**FINAL ENGINEERING PLANS
FOR
SUMMIT HOUSING GROUP - MULTIFAMILY SITE**

TRACT A, BLOCK 3

LYONS VALLEY PARK FILING NO. 8

COVER SHEET
SUMMIT HOUSING GROUP
LYONS VALLEY PARK FILING NO. 8
LYONS, COLORADO

**CIVIL SITE PLAN
SUMMIT HOUSING GROUP
LYONS VALLEY PARK FILING NO. 8
LYONS, COLORADO**

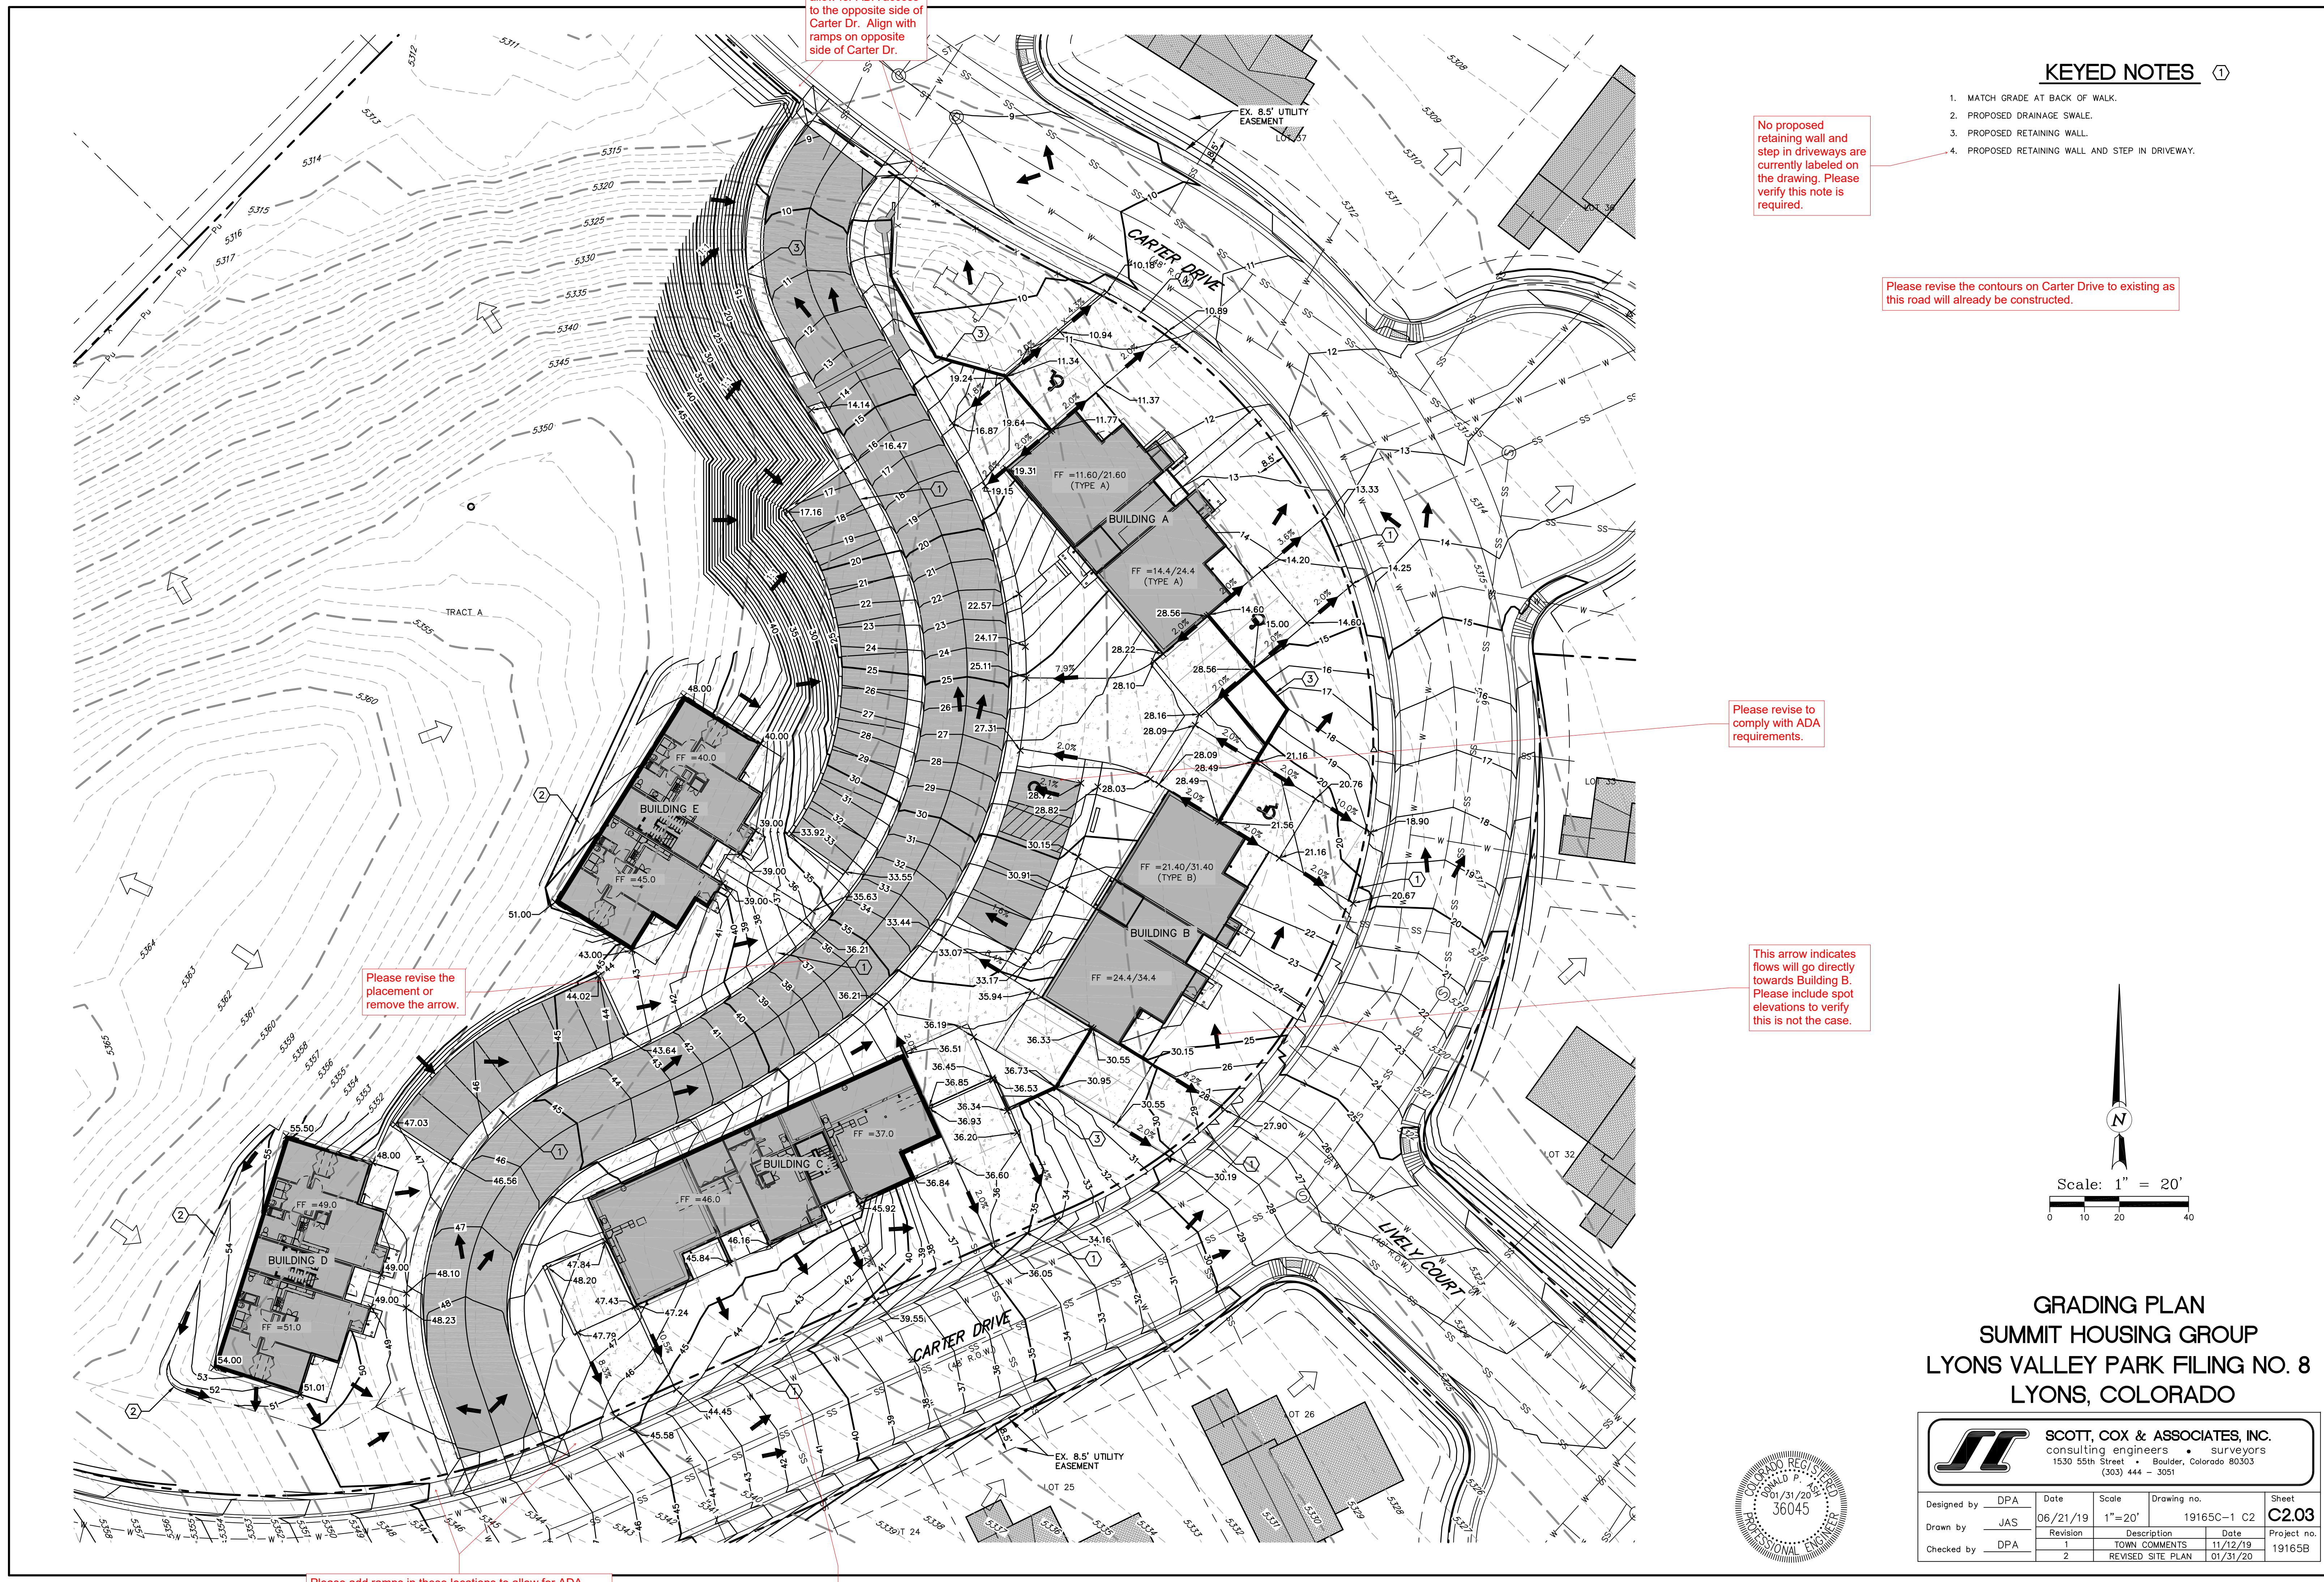
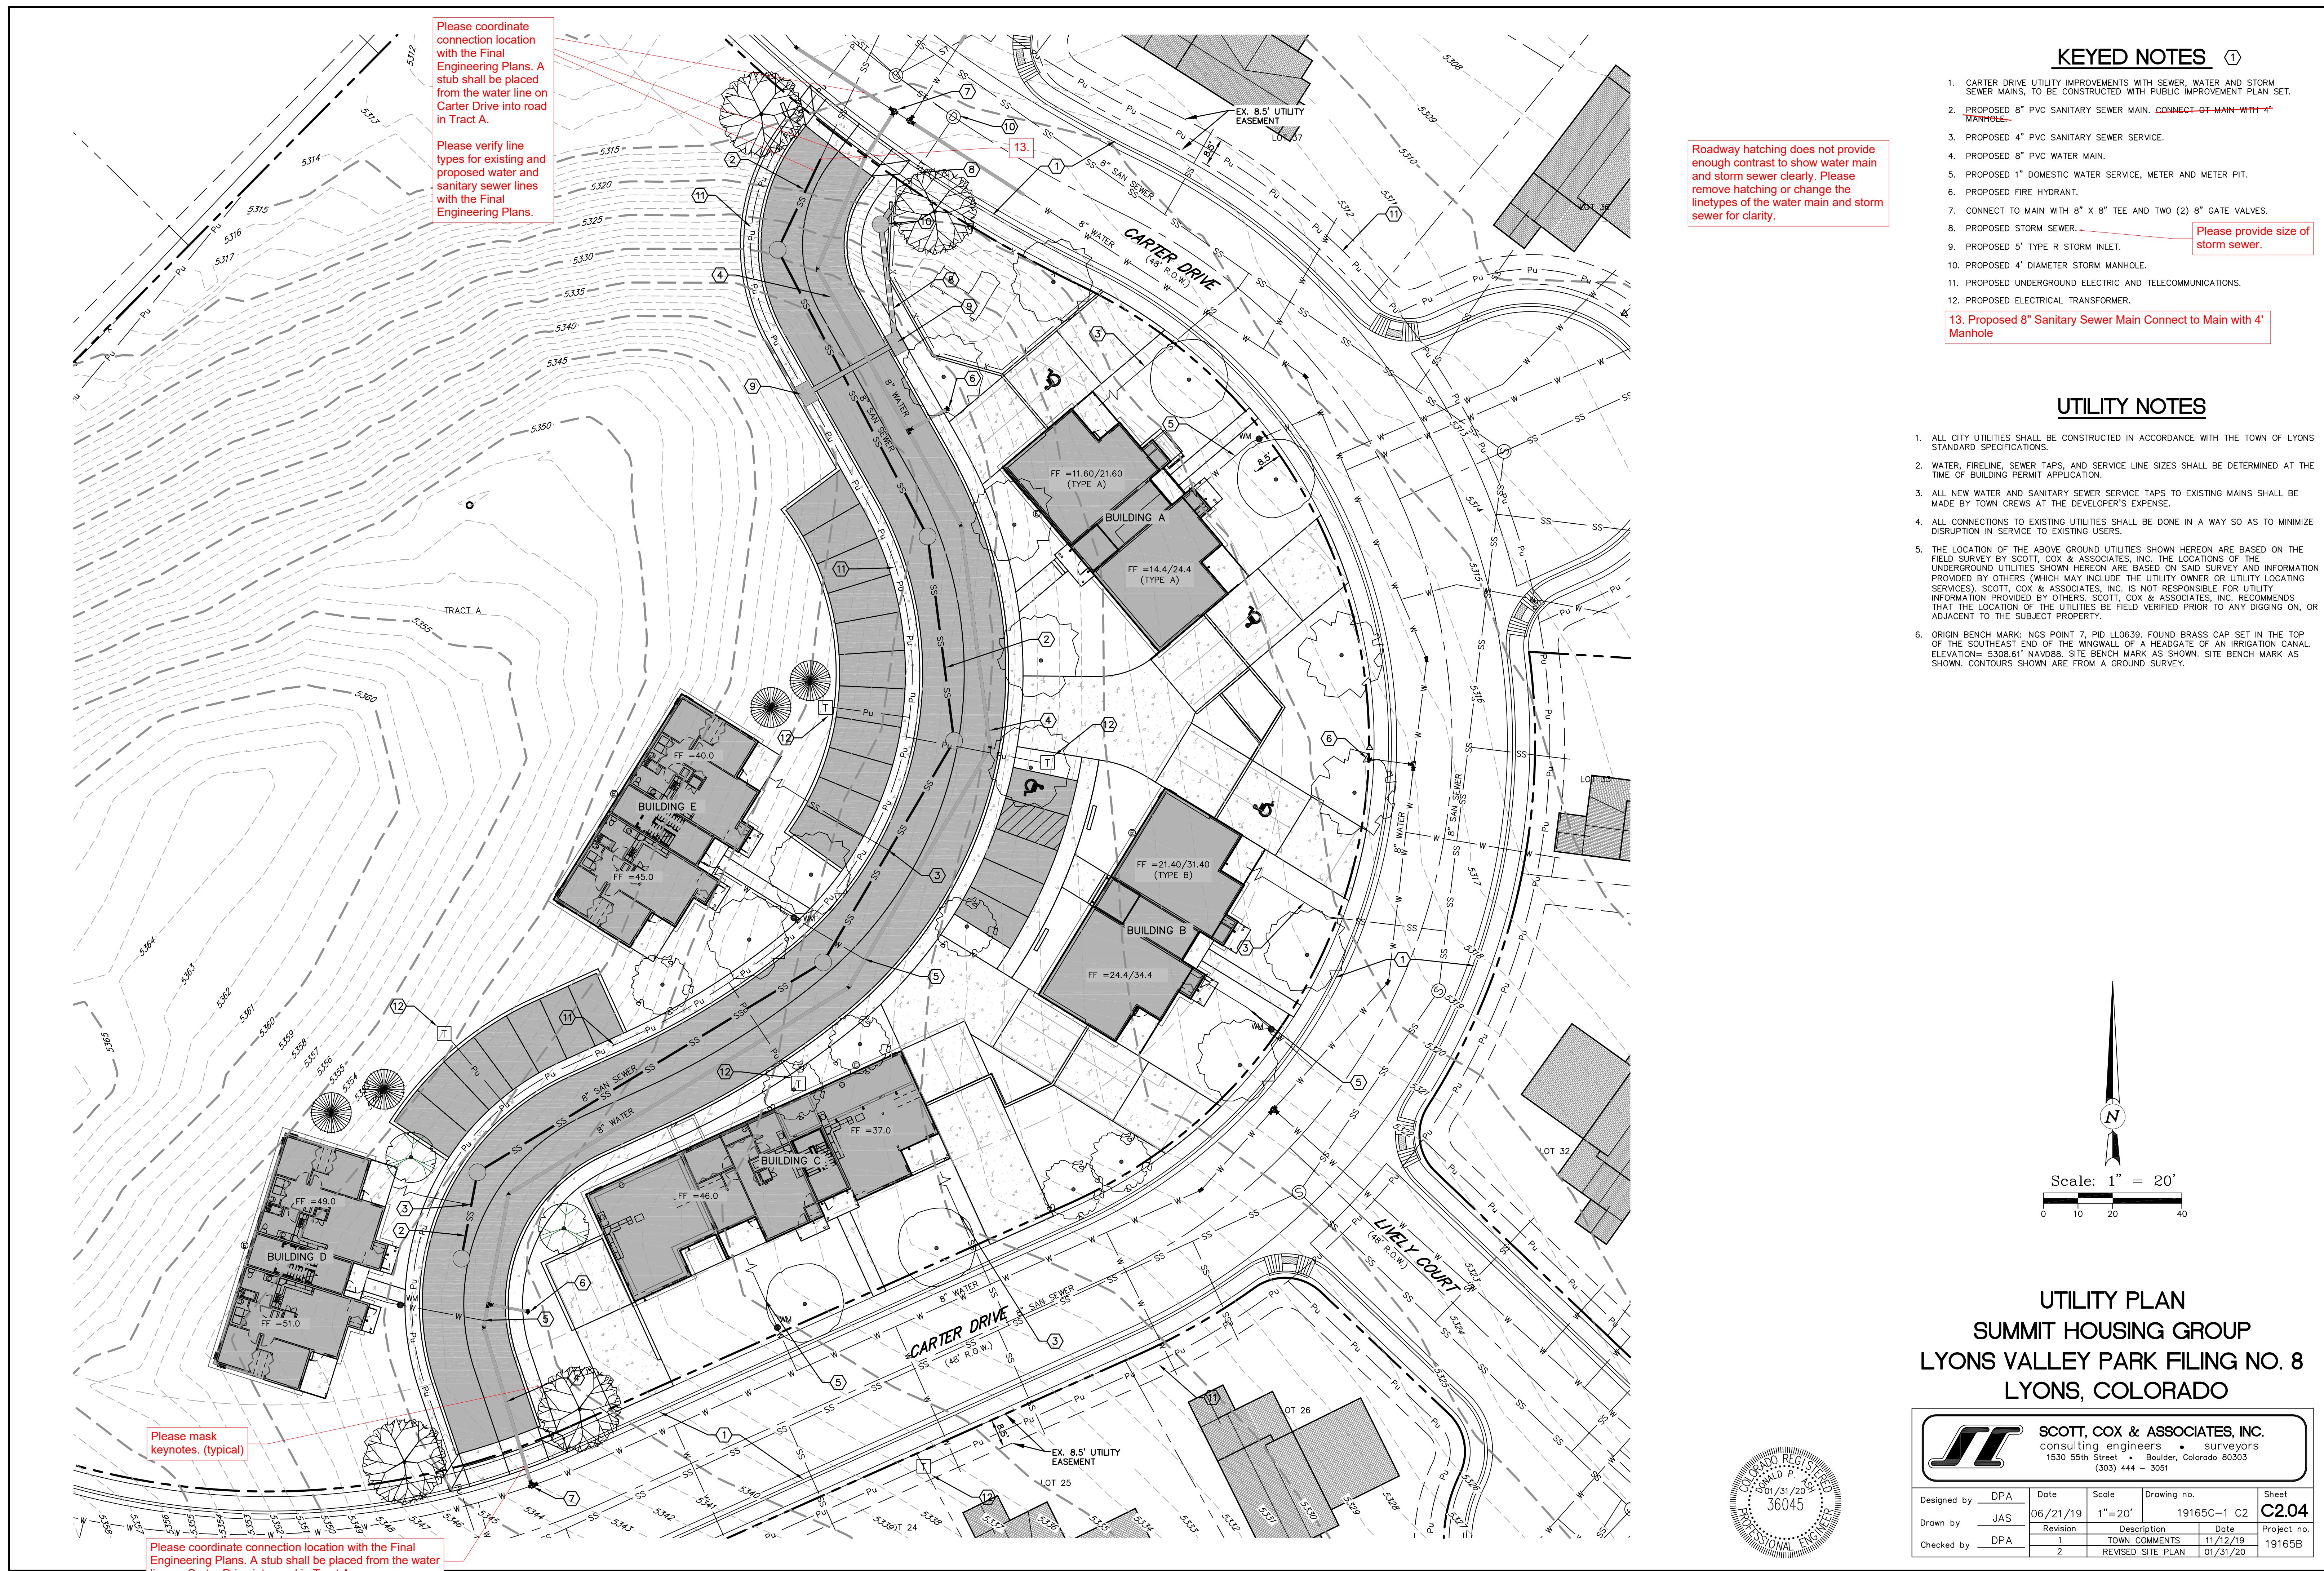
Roadway hatching does not provide enough contrast to show water main and storm sewer clearly. Please remove hatching or change the linetypes of the water main and storm sewer for clarity.
